- 1. Bunnell's Subdivision 2023 Replat; KPB File 2023-047**  
**Ability Surveys / Malone, Hendrix**  
**Location: Swatzell Street & West Pioneer Avenue**  
**City of Homer**

## BUNNELL'S SUBDIVISION 2023 REPLAT

ITEM #1 - Bunnell's Subdivision 2023 Replat

### Staff Report 23-025

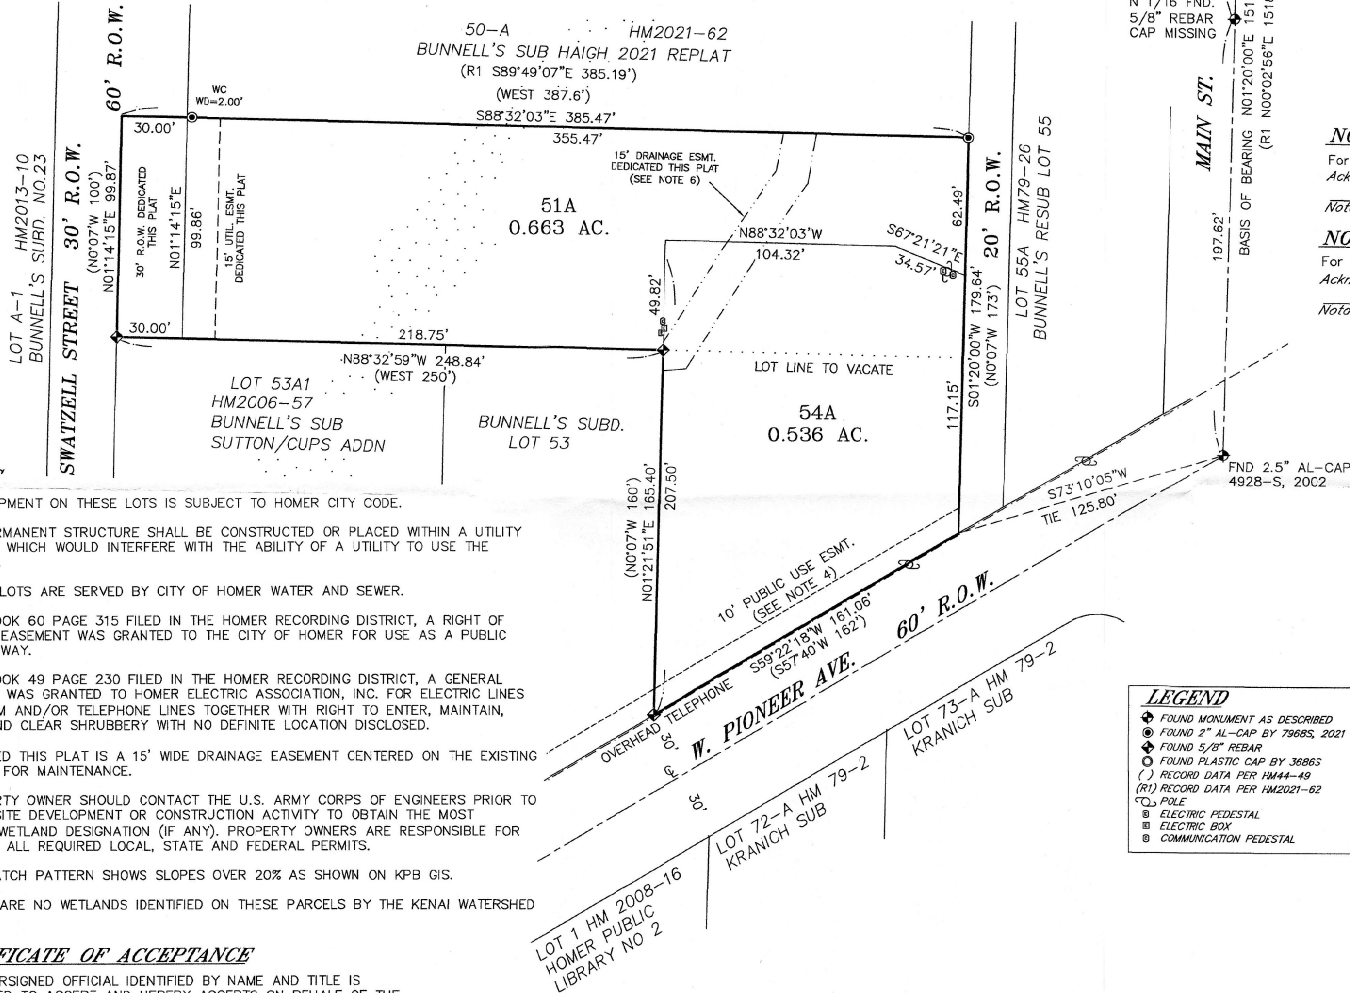
**Site Investigation:** The terrain is flat near Swatzel Street and then drops along a slope to the east towards the natural drain way in the back of proposed Lots 51A and 54A. Then the terrain is relatively flat draining towards W Pioneer Ave. The City of Homer has requested a 15 foot drainage easement be added along the drain way. **Staff recommends:** adding the drainage easement to the *Certificate of Acceptance*.

There is a proposed 15 foot utility easement proposed along the dedication for Swatzel Street as shown on the subdivision drawing. **Staff recommends** adding the 15 foot easement to W Pioneer Ave side of Lot 54A.

**Staff recommendation:** Add "City of Homer" to the title block.

**Staff recommendation:** Label adjacent alley "Alley"

- D. A vicinity map, drawn to scale showing location of proposed subdivision, north arrow if different from plat orientation, township and range, section lines, roads, political boundaries, and prominent natural and manmade features, such as shorelines or streams;  
**Staff recommendation:** Label where Pioneer Avenue end and East End Road begins.

**Staff recommendation:** place the standard note on the plat for the flag lot(s): No structures are permitted within the panhandle portion of the flag lot(s).

**Staff recommendation:** comply with 20.60.110. there is a difference in the north south distances originating near W. Pioneer Ave, verification is needed of the distances and pins along the right-of-way.

- *"No access to state maintained rights-of-way permitted unless approved by the State of Alaska Department of Transportation."*

**Staff recommendation:** Add the 15-foot drainage easement to the certificate of acceptance and comply with 20.60.190.

1. There will need to be a drainage easement that continues from Lot 50-A.
2. Dedicate a 15' drainage easement centered on the creek of Lots 51A and possibly through the north west corner of lot 54A.
3. Dedicate a 15' utility easement fronting the newly dedicated Swatzell Street.
4. There currently exists a water and sewer stub out for lot 51A on the south east property boundary. These services will need to be relocated north as to serve the lot directly and not via an easement.
5. The property owner will need to relocate the services prior to recording the plat, or enter into an installation agreement with the City, in which they will bond the cost of relocating the services in an agreed upon time frame. This will allow the plat to be recorded prior to the work being completed.

2. Dedicate a 15' drainage easement centered on the creek of Lots 51A and possibly through the north west corner of lot 54A.
3. There currently exists a water and sewer stub out for lot 51A on the south east property boundary. These services will need to be relocated north as to serve the lot directly and not via an easement.

4. The property owner will need to relocate the services prior to recording the plat, or enter into an installation agreement with the City, in which they will bond the cost of relocating the services in an agreed upon time frame. This will allow the plat to be recorded prior to the work being completed.
